North Little Rock Planning Commission
March 10, 2026 - Agenda / Public Hearing 4:00 PM
City Council Chambers – 300 Main Street, NLR, AR 72114

**North Little Rock Planning Commission
Minute Summary
February 10, 2026**

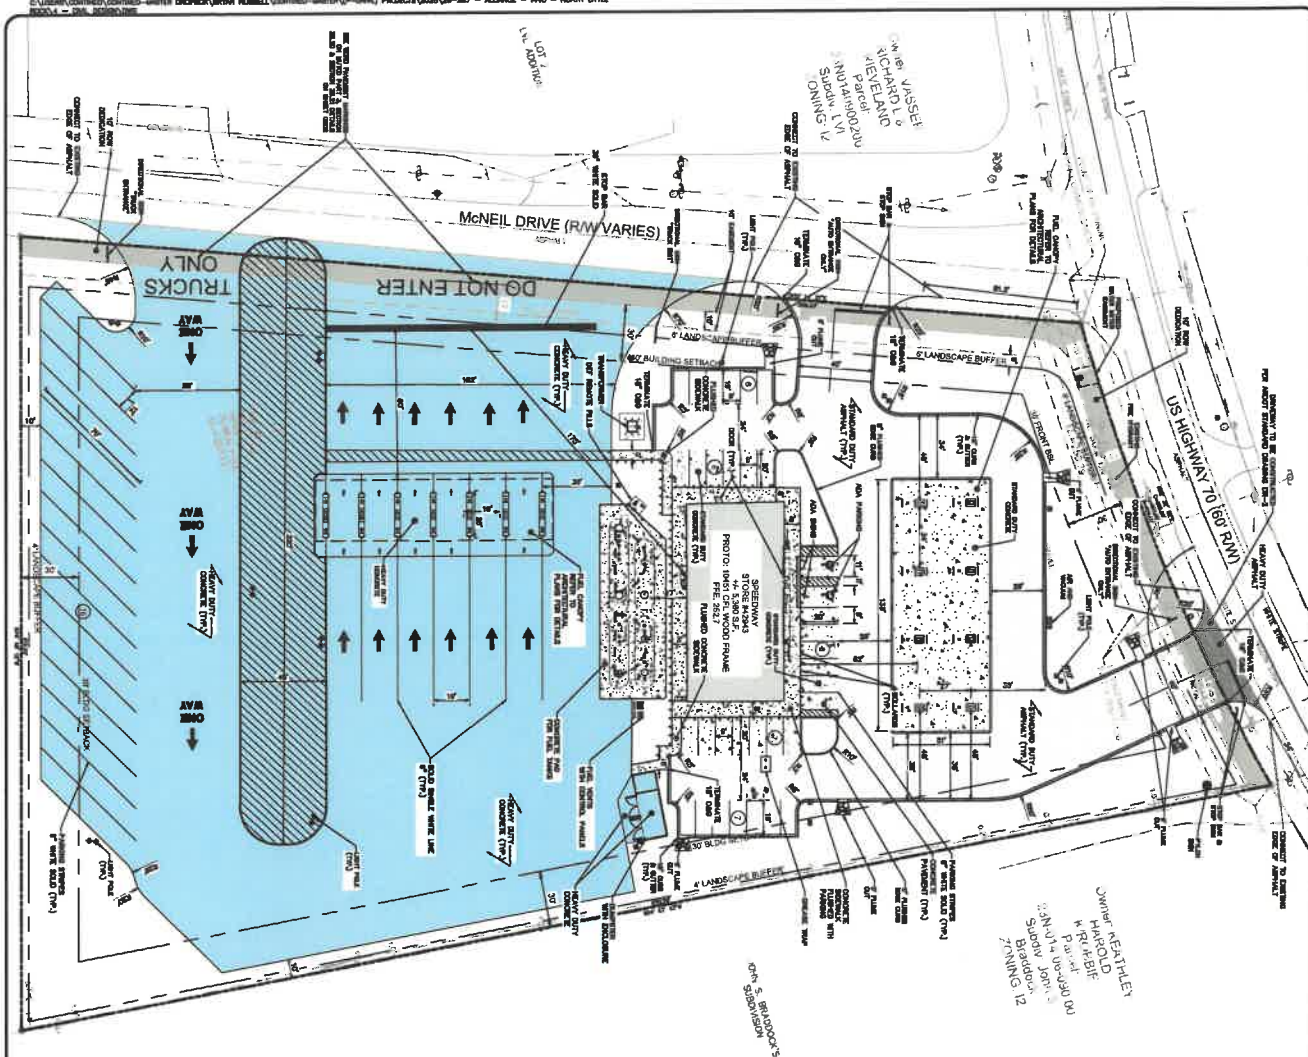
- ii. Fire Apparatus access roads shall have an unobstructed vertical clearance of not less than 13 feet 6 inches. (Volume 1 Section 503.2.1)
 - iii. Fire Apparatus access roads shall extend to within 150 feet of all portions of the exterior walls of the first story of the building. (Volume 1 Section 503.1.1)

- iv. Where there is a divided entrance each lane shall be a minimum of 15 feet clear. (Volume 1 Section 503.2.1.1)
 - v. Dead end roads in excess of 150 feet shall be provided with width and turnaround provisions in accordance with Table D103.4. (Volume 1 Appendix D103.4)

- vi. There shall be a fire hydrant within 400' of any portion the building if unsprinklered, within 600' if sprinklered. (Volume 1 Section 507.5).
 - b. Place required warning information at each fuel pump. (Volume 1 Section 2304.3.5 & 2305.6)

- c. Fire Apparatus access roads will support 85,000 lbs. (Municipal Code Chapter 12, Article 3.2.4 D)
 - d. An approved emergency disconnect switch shall be provided at an approved location, if on the exterior it shall be within 100 feet but not less than 20 feet from the fuel dispensers. (Volume 1 Section 2303.2)
